2 Type of change

- Change of approval markings

Product Change Notification					PCN for 4022 and 8101		
owner	creation date	release date	released by	change order no	rev	page	D10-028-565
bachmajo	16.08.2018	20.09.2018	limachcl	2016061	A	1 of 4

3 Detailed description of change

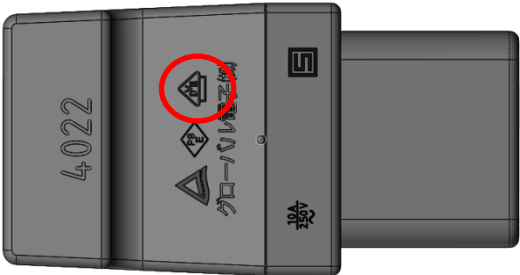
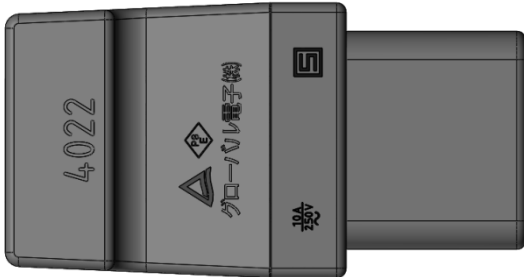
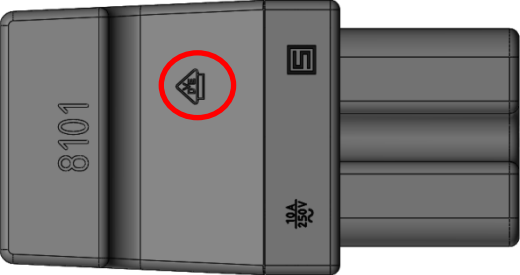
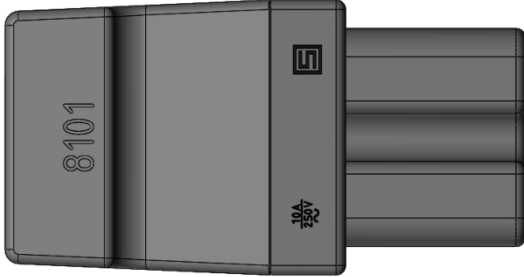
The VDE approval markings on the product and the packaging label will be removed from the types 8101 and 4022.

SCHURTER suggests using the Types 4781 and 4782 as an alternative with a valid VDE approval.
